Office Action Summary

10/810,905

DETAILED ACTION

FIG. 4

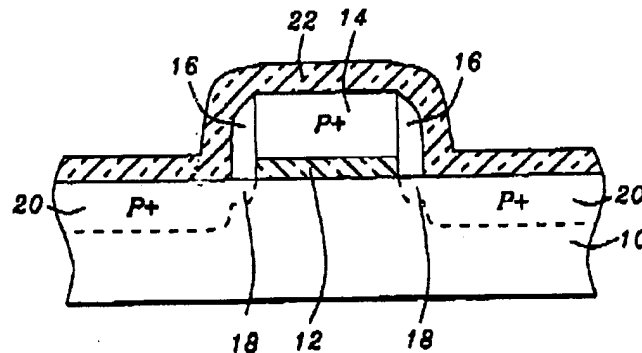
providing a semiconductor substrate having a P-type dopant region to support an N-channel transistor and an N-type dopant region to support a P-channel transistor, each of the N-type dopant and P-type dopant regions having an overlying gate stack including a conductive gate structure and a dielectric gate structure (Fig. 4 and Abstract);

forming lightly-doped extension regions in the semiconductor substrate adjacent each gate stack (Fig. 4 #18);

forming a layer of insulating material over the lightly-doped extension regions Fig. 4 #16);

forming an interfacial layer of nitrogen at the interface of the insulating layer and the lightly-doped extension regions (the gate dielectric 12 and spacers 16 can be silicon nitride, thus Fig. 4 above will inherently have Nitrogen at the interface between the insulating material and the LLD.)

forming source and drain regions in the semiconductor substrate adjacent to each of the gate stacks (Fig. 4 #20);

Forming at least one sidewall layer (Guo, Fig. 4 #16 - is clearly a sidewall layer, it is also further noted Takenough additionally depicts forming at least one sidewall layer in figure 2C #36')

forming a capping layer of contiguous silicon nitride over the semiconductor substrate and each of the gate stacks (Fig. 4 #22);

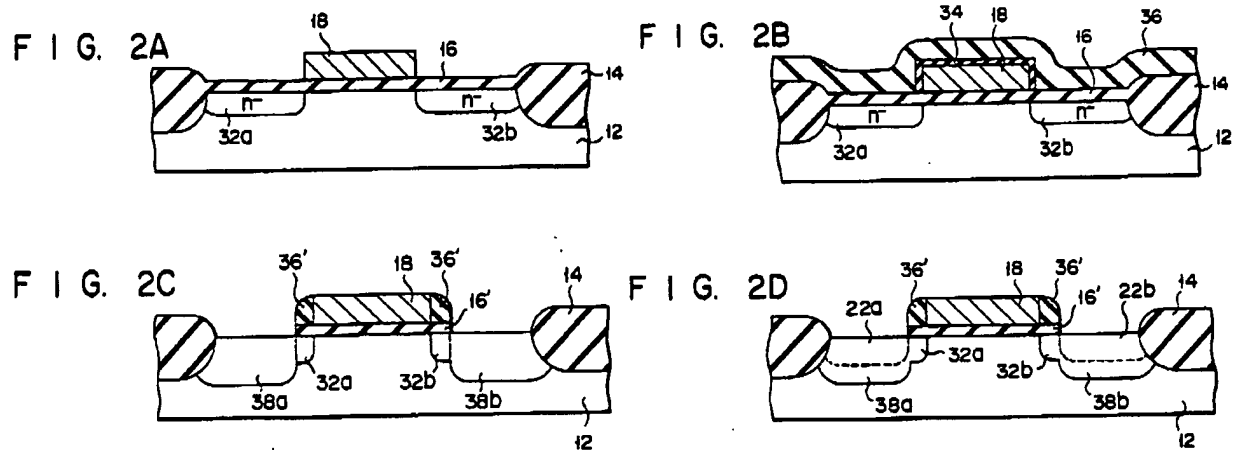
Guo does not specifically disclose "forming a layer of insulating material over the total exposed surface of the lightly-doped extension regions. Guo discloses that the insulating layer is formed prior to forming the LDD region. It is however well understood and established in the art the LDD regions can be formed before or after the insulation layer is formed. An example of this is disclosed by Takenough et al. in figures 2A-2D.

FIG. 3**FIG. 4****FIG. 5**

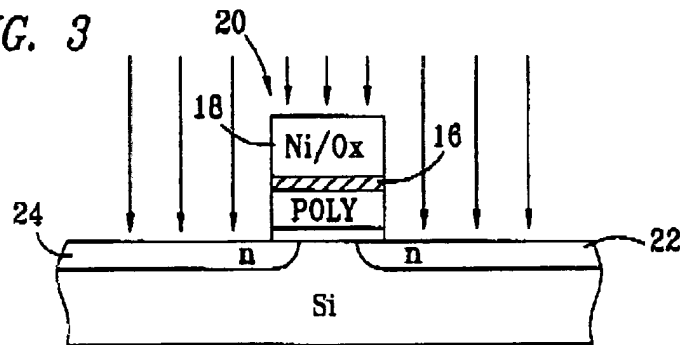
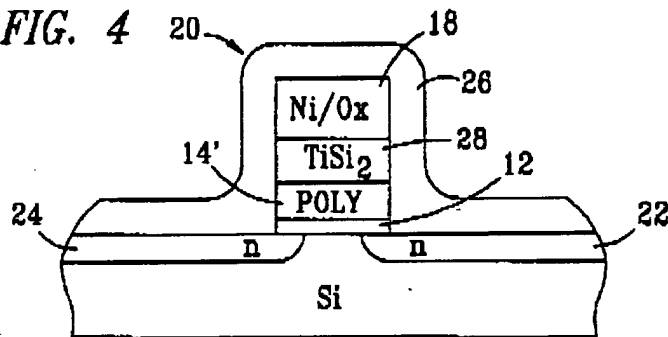
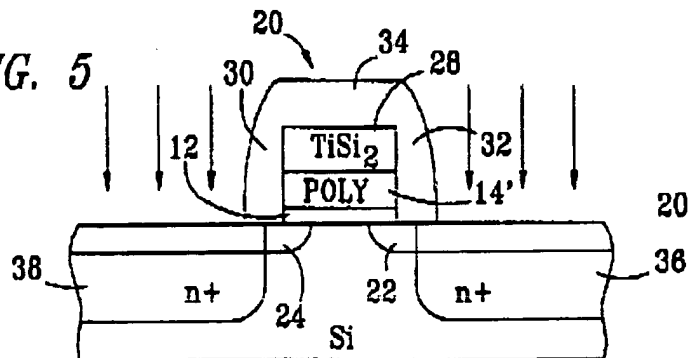
The combination of Takenough and Gou show it was obvious at the time of the invention to form the LDD regions before or after the formation of the sidewalls (thus covering the "exposed" LDD regions). The Takenough reference does not teach the newly added limitation that the insulating layer formed over the exposed region is in direct contact with the exposed region. It was however notoriously well known at the time of the invention that the oxide layer [16] of Takenough can be removed or left because it does not significantly effect the LDD implanting process. An example of this

is clearly disclosed by Liu. The Liu patent discloses additionally removing the oxide layer while patterning the polysilicon gate prior to performing the self-aligned LDD implant, the performing the steps of a layer of insulating material in contact with the total exposed surface of the lightly-doped extension regions (Liu, Figures 3-4).

FIG. 3

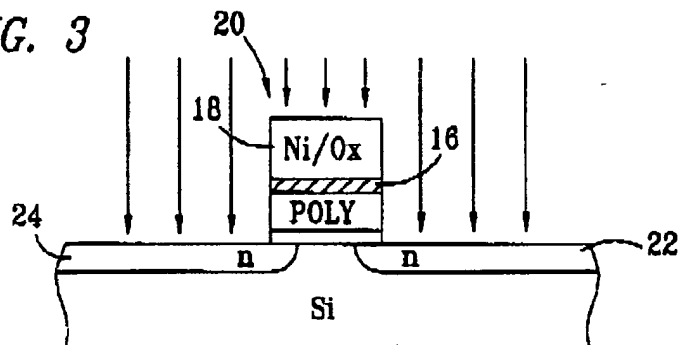
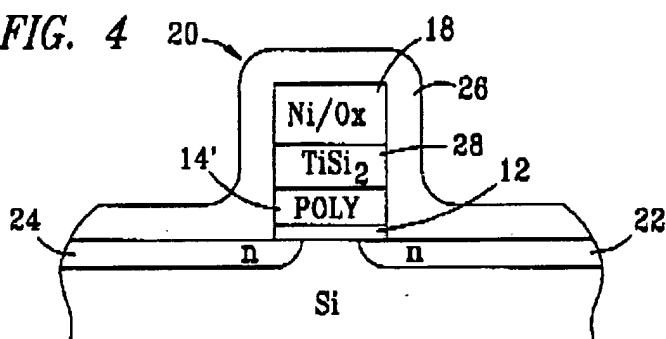
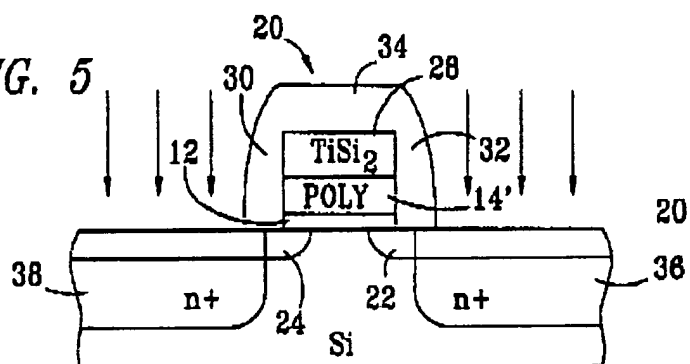
The combination of Takenough and Gou show it was obvious at the time of the invention to form the LDD regions before or after the formation of the sidewalls (thus covering the "exposed" LDD regions). The Takenough reference does not teach the newly added limitation that the insulating layer formed over the exposed region is in direct contact with the exposed region. It was however notoriously well known at the time of the invention that the oxide layer [16] of Takenough can be removed or left because it does not significantly effect the LDD implanting process. An example of this is clearly disclosed by Liu. The Liu patent discloses additionally removing the oxide layer while patterning the polysilicon gate prior to performing the self-aligned LDD implant, the performing the steps of a layer of insulating material in contact with the total exposed surface of the lightly-doped extension regions (Liu, Figures 3-4).
